27 May 2026

RE: Request to Amend Regional Interest Development Approval RPI25/002 Anglo American – Planet Downs Project (Exploration Drilling)

Figure 1 RIDA Attachment 1 – Approved Plan

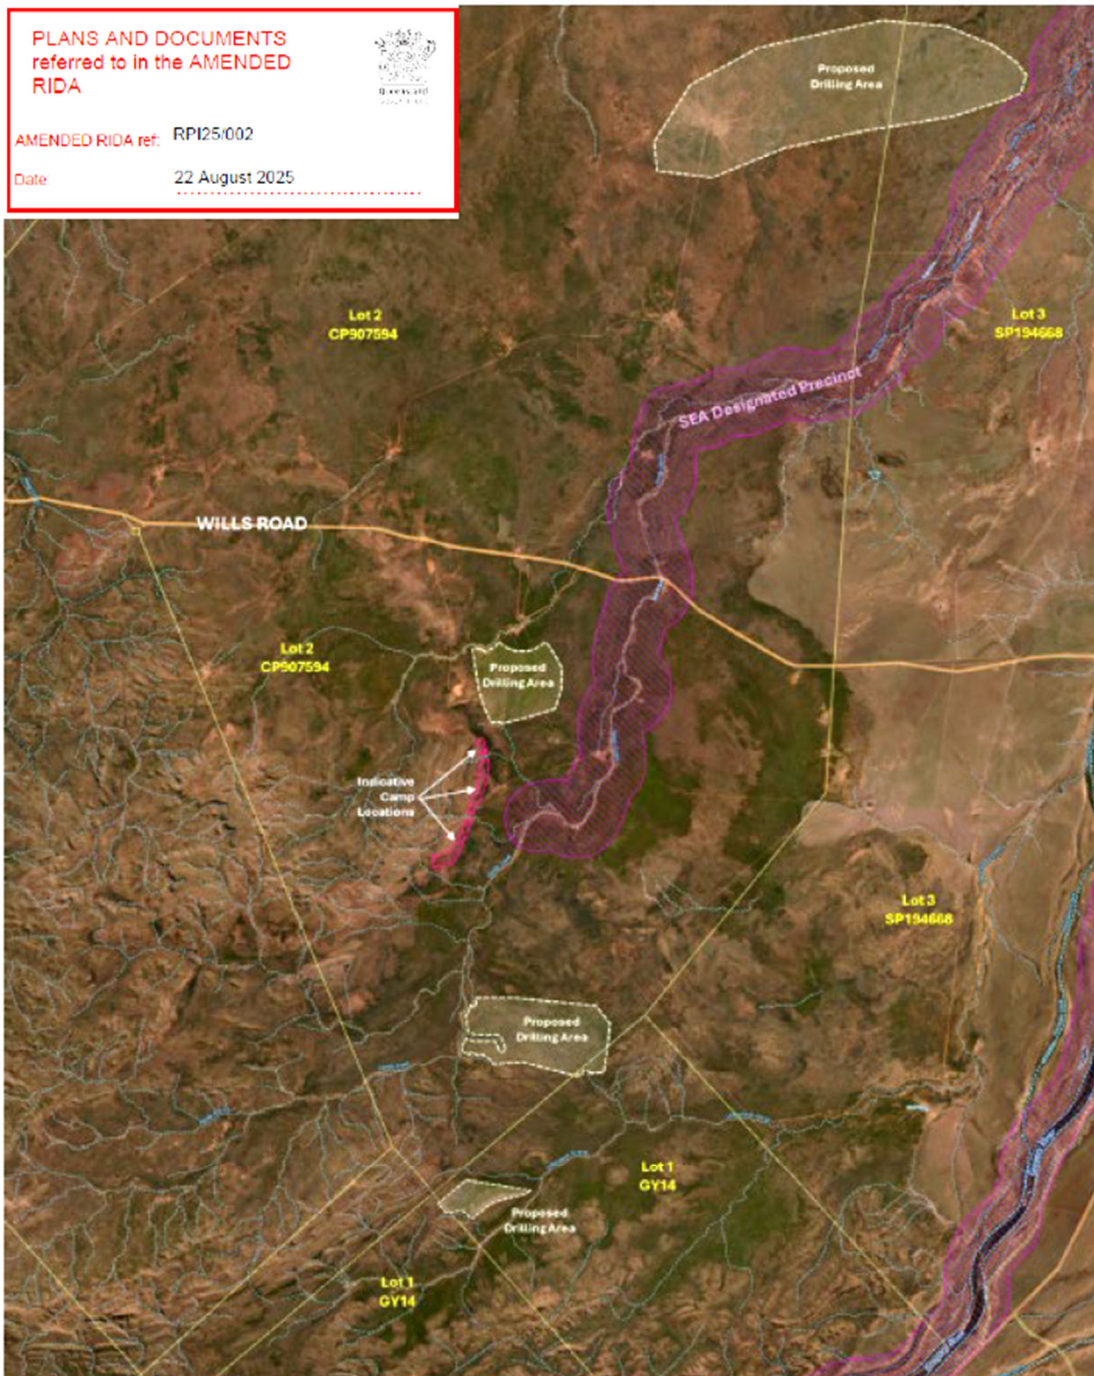
On 3 July 2025, Anglo submitted a RIDA amendment application to revise the locations of the Proposed Drilling Areas, and this amendment was approved on 22 August 2025. The Approved Plan, showing the revised locations of the Proposed Drilling Areas, is provided in **Figure 1**.

Figure 2 Comparison of Current Approved Plan with Requested Amendment showing Changes to Proposed Drilling Areas

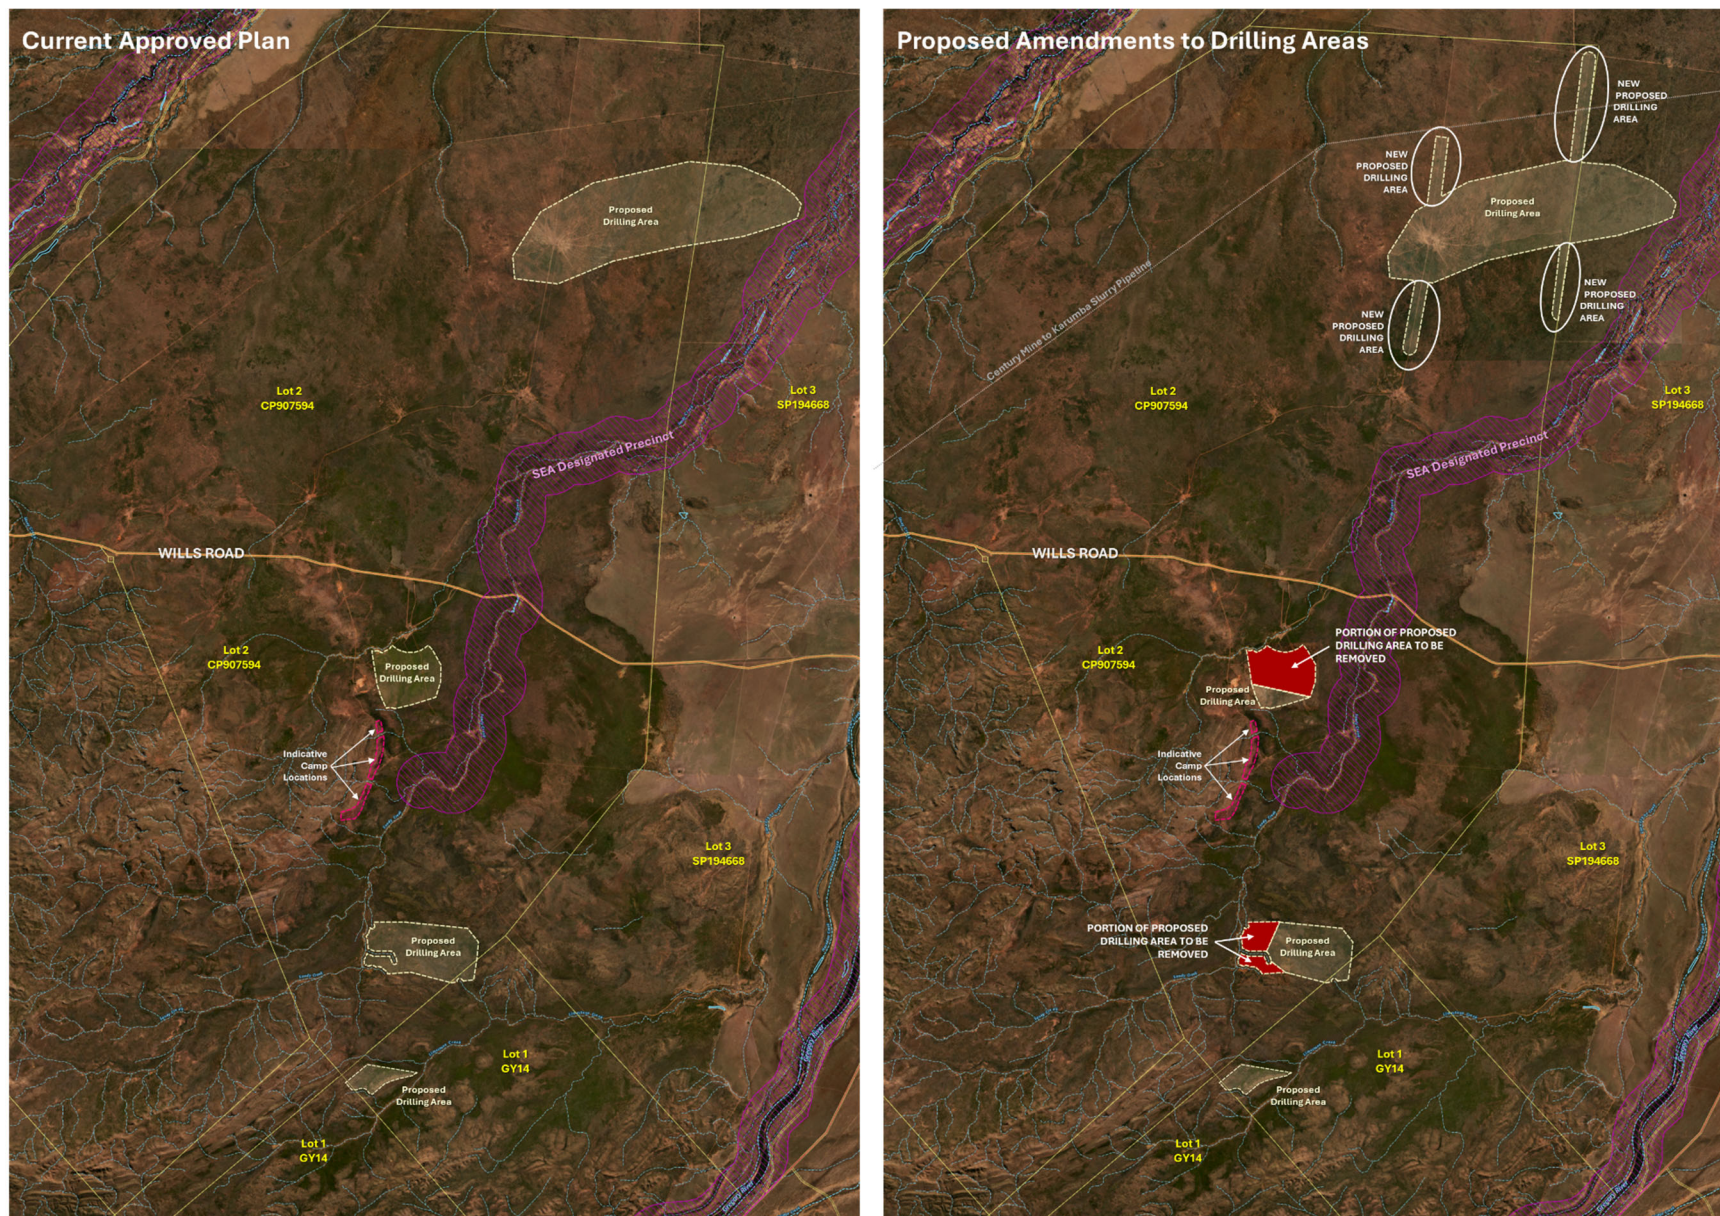
Anglo is therefore proposing the addition of new drilling areas, and to reduce the size of some of the existing drilling areas (refer **Figure 2**). The total of the new Proposed Drilling Areas covers a combined area of approximately 4,324 ha, which is of similar size to the current approved drilling areas (which covers approximately 4,346 ha).

It should be noted that Anglo has not undertaken any activities within the portions of the drilling areas proposed to be removed from the exploration program.

A portion of the northern portion of the new proposed drilling area overlaps easement GSP110463, relating to the Century Mine to Karumba slurry pipeline and associated public utility easement under the *Land Act 1994* (as described in Schedule 1 Part 2, and shown in Schedule 5, of the *Century Zinc Project Act 1997*) (refer **Figure 2**). Anglo is aware of this easement and will not undertake any drilling activities within this easement.

Figure 3 Amended Proposed Drilling Areas in Relation to Mapped Waterways and SEA Designated Precinct

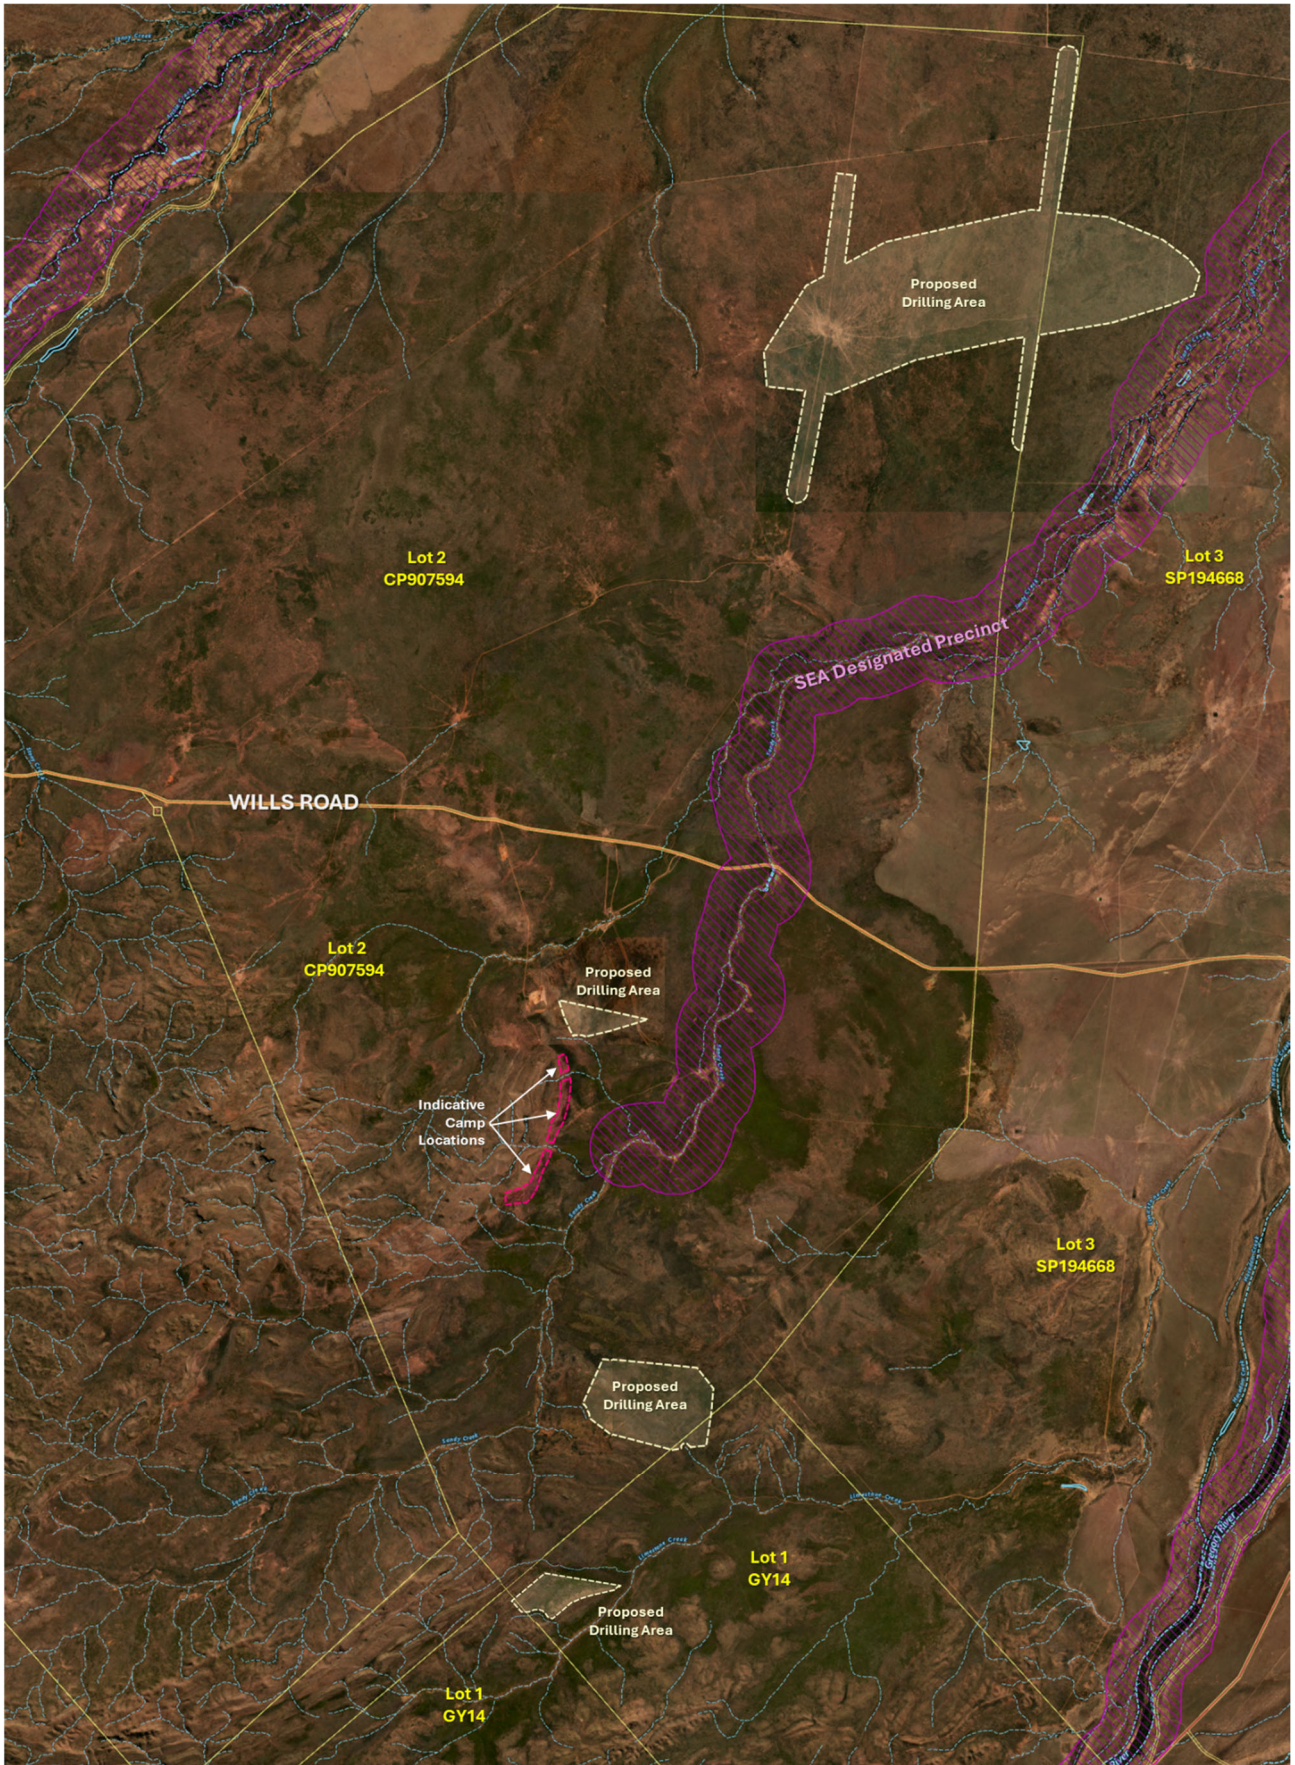
The New Proposed Drilling Area is located at least 100 m from mapped drainage features (refer **Figure 3**) and does not contain any mapped wetlands or springs. No creek crossings are required to be constructed for activities within the New Proposed Drilling Areas.

- *Attachment 1 – Approved Plan:*
 - A revised figure to be included as Attachment 1 – Approved Plan, as provided in **Figure 3**.
- *Condition 1(c):*
 - Suggested amended wording for condition 1(c), which references the figure provided in the current RIDA, is provided as red text in **Table 2**.
